UNITED STATES
CLEAR REGULATORY COMMISSION
WASHINGTON, D. C. 20555

Enclosure:
Response to Safety
Allegations by Mr. R. Brown

Response to Safety Allegations
Made by Mr. Robert Brown

FIGURE 3

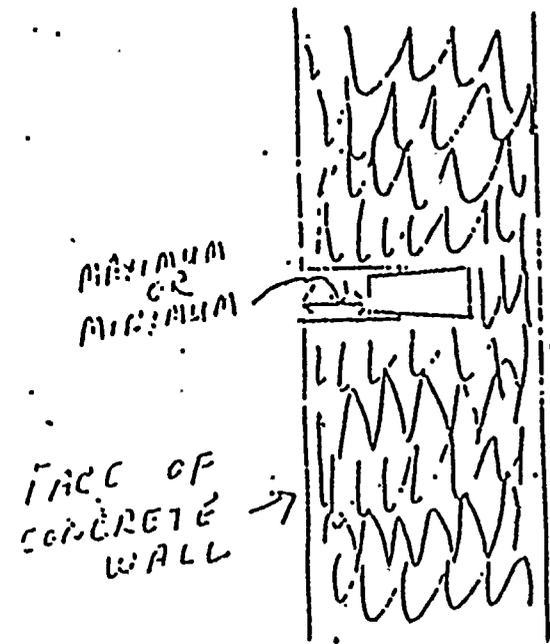
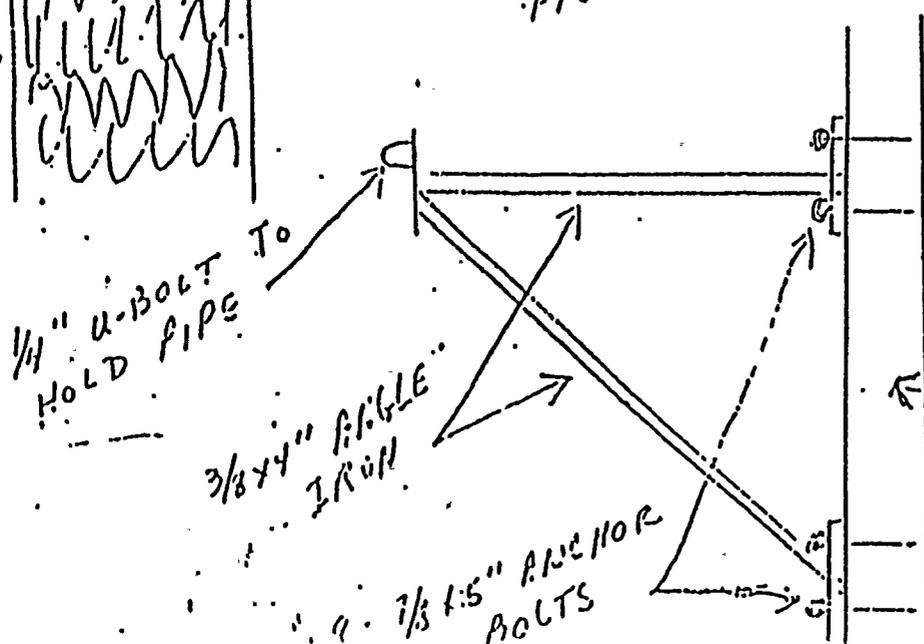
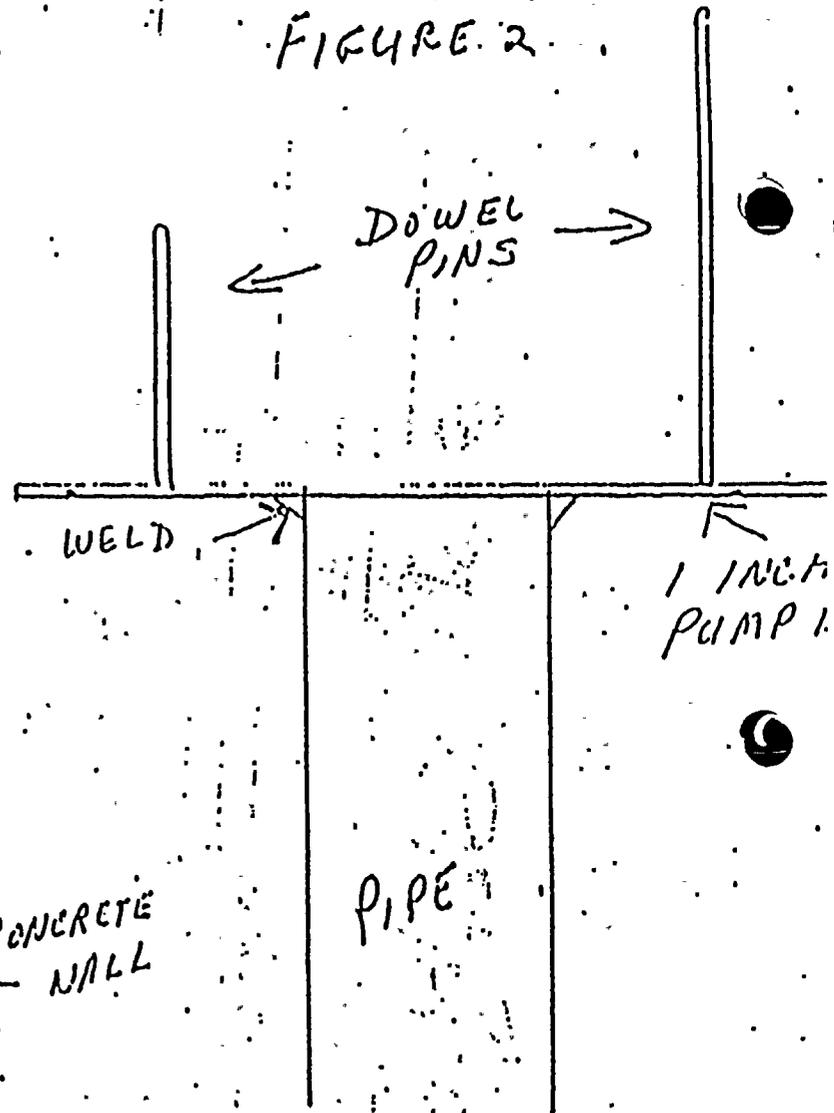
3. Pipe supports are designed for heavy loads then the pipes are attached by a weaker link.

1/4" U-BOLT TO HOLD PIPE

3/8x4" ANGLE IRON

9 - 7/8x5" ANCHOR BOLTS

While licensee representatives were unable to identify the current use of 1/4" U-bolts in pipe supports, it was found that some 1/4" U-bolts had been installed in the past and that this condition was subjected to engineering review and properly dispositioned. The Burns & Roe program for reviewing the designs of completed pipe support assemblies provides for an analysis to verify the as-built condition of the support thus providing reasonable assurance that the support will perform its intended function.

The fact is that the anchor to the concrete is given a larger margin of safety in order to reflect somewhat less capability to perform an "exact analysis" on the load capability, whereas the determination of load capability for a U-bolt clamp is more direct. The allegor addressed this item apparently due to cost considerations.
